GENERAL APPLICATION

SUBJECT: Preliminary Site Plan review for a 15-unit residential development (Mayo Apartments).

PROPOSED 15-UNIT MULTI FAMILY
DEVELOPMENT FOR:
XLT INVESTMENT CORP.
1700 MAYO STREET
HOLLYWOOD, FLORIDA 33020

SURVEYOR'S CERTIFICATION

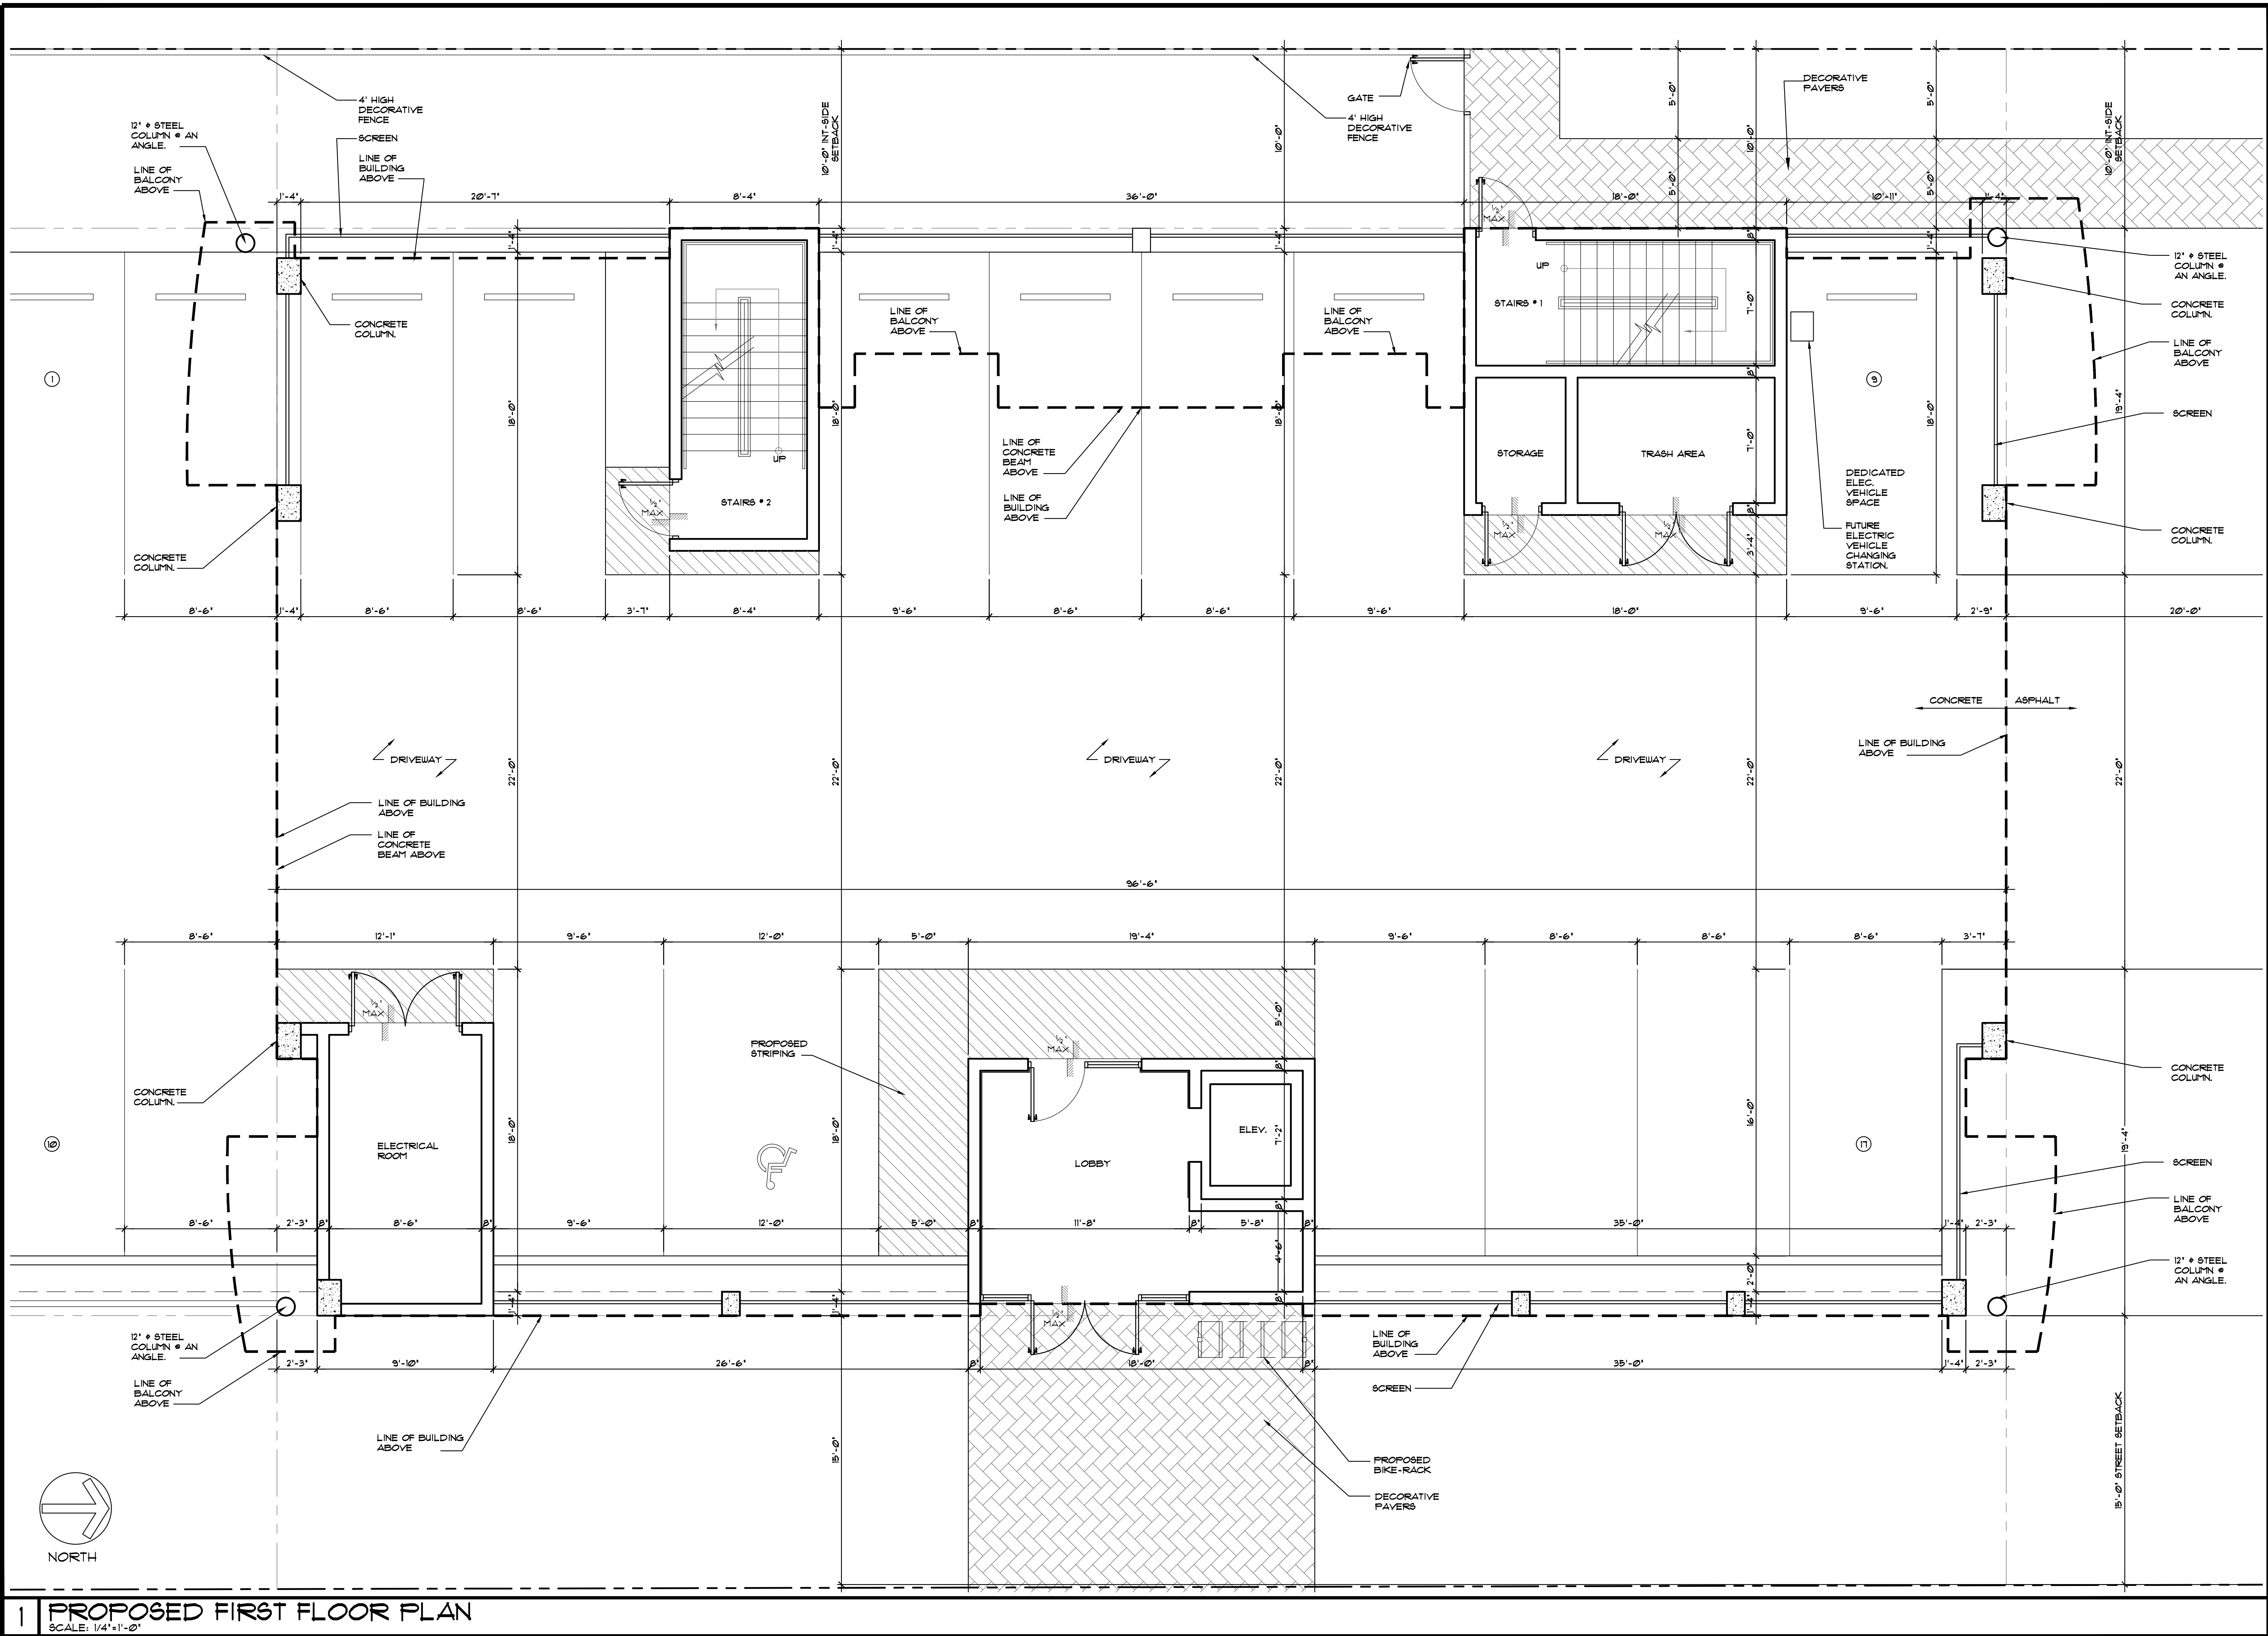
1. Update survey to clearly specify elevations shown are in reference to the NAVD 88 datum as on Sheet C-1.1.
Response: OK
2. Correct Surveyor's Certificate Note #6 FEMA to indicate the property DOES lie within special flood hazard zone AE7. This means the proposed finished floor elevation (FFE) for new construction shall be set at Base Flood Elevation (BFE) + 1' to comply with City Ordinance Chapter 154.50. The proposed FFE shall be $(7' + 1' =) 8'$ NAVD88 since this condition is greater than 18-inches above the highest point of the crown of the adjacent road $(3.84' + 1.5' = 5.34'$ NAVD 88).

Response: Provided
3. Revise the Panel No. to 12011C0732 in Note #6.
Response: revised
4. Show existing 2-inch water main within alley and corresponding water meter on Sheet C-1.1.
